GROUP	MODEL
ENG	2021-2024MY K5 (DL3a) w/Theta III 2.5L T-GDI
NUMBER	DATE
260	November 2025

## TECHNICAL SERVICE BULLETIN

### ITM REPLACEMENT AND ECM LOGIC IMPROVEMENT (CA2511)

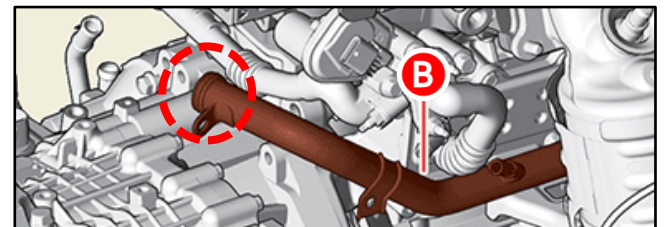
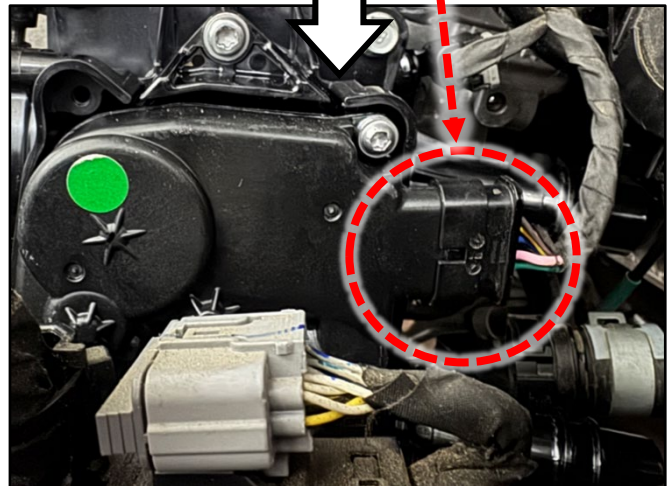
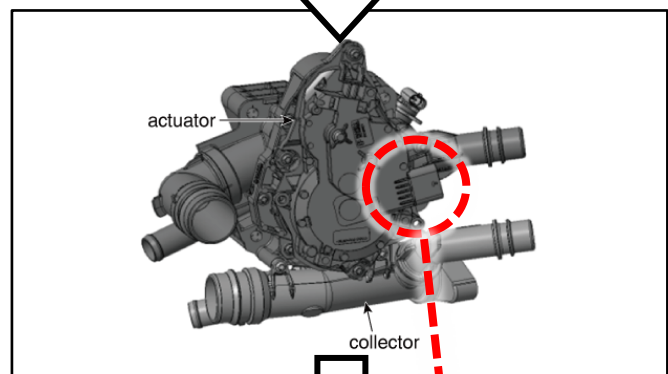
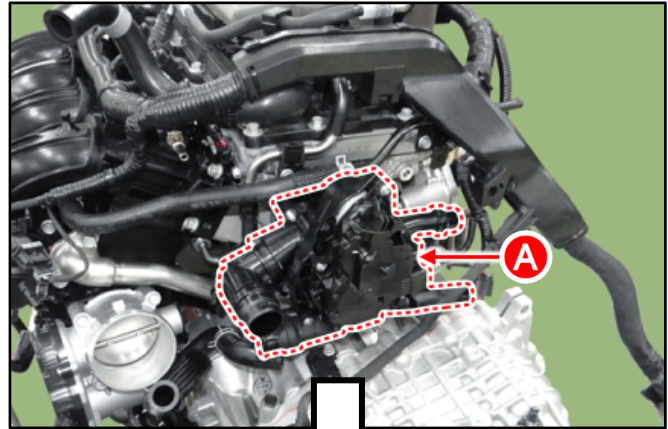
1. Replace the Integrated Thermal Management Module 'ITM' (A) by referring to "Engine Mechanical System → Cooling System → Integrated Thermal Management Module (ITM) → Repair procedures" in the applicable Shop Manual on KGIS.

Tightening torque for bolts:  
7.2 - 8.7 lb.ft (9.8 - 11.8 N.m)

**DO NOT** disassemble the **actuator** and **collector**. The new ITM is supplied as an assembly unit.

**Note:** The **ITM connection orientation** changes after replacing the new ITM part. The locking tab will face the engine.

Trying to make the connection on the new ITM in the same orientation as the original ITM may damage the connector pins/terminals.

3. Install a new inlet pipe (B) O-ring on the **red circled** area shown.
4. Proceed to upgrade the 'ECM' with Event 850 software in **Manual Mode** only, **after** ITM part replacement is completed by referring to the ROM ID table on page 4.
5. Verify normal vehicle operation.
